17/1778/FUL | Single storey steel frame unit for home delivery service. | Morrisons Car Park Polsloe Prince Charles Road Exeter Devon EX4 7BY

16th January 2018

Figure 1: Showing (A) details omitted from the Design and Access Statement ie (i) existing vehicular access at east end of the Morrisons customer car park and (ii) E4 strategic cycle route (B) proposed mitigation by closing access for customers.

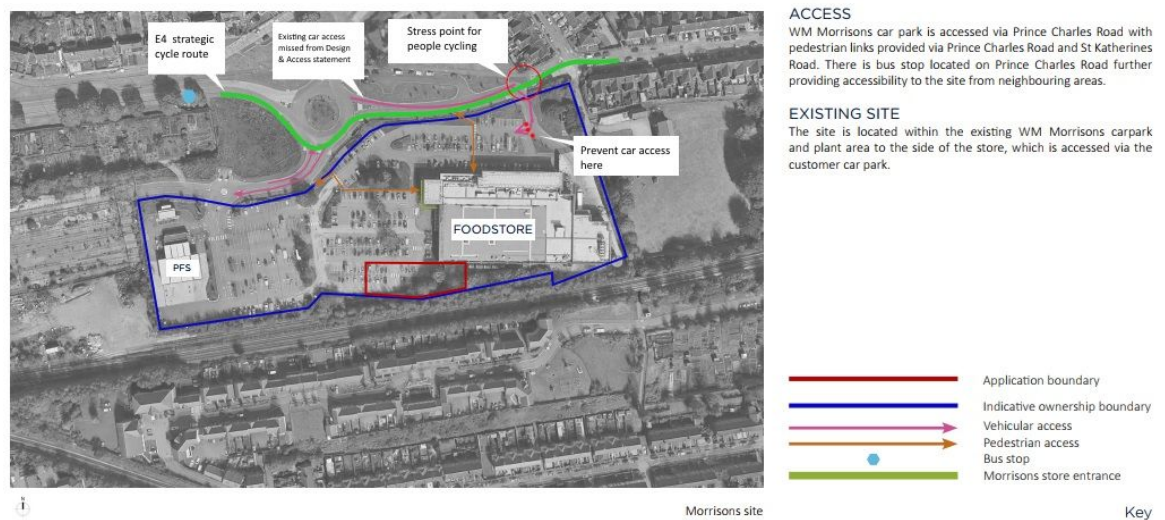
The DAS **fails to acknowledge** the existing vehicular access to the eastern end of the Morrisons customer car park. This access road from Prince Charles Road (just to the west of the 'one way' connection to St Katherines Road) is used by articulated HGVs arriving at/leaving Morrisons Service Yard, but also a significant number of customers driving to/from the store. This access already poses a safety hazard for cyclists using the strategic E4 cycle route, which crosses the junction of the access road. No priority is currently given to cyclists (or pedestrians) at this junction, which does not meet best practice standards and falls far short of what is expected from a strategic route. The plans submitted by Morrisons indicate an increase in floorspace to accommodate the home delivery service, including additional chilled storage. While not acknowledged in the DAS, an increase in sales volume associated with the introduction of home delivery options will undoubtedly lead to more frequent deliveries to the store. These will likely be made by HGVs to the existing service yard, and will therefore **increase conflicts with pedestrians and cyclists** crossing the service yard access road.

- **Permanently closing the customer access from the eastern side** of the car park to the service yard access road. This would mitigate any potential increase in HGV deliveries to the service yard by removing vehicle traffic to the general public, while potentially maintaining access for cycles ;
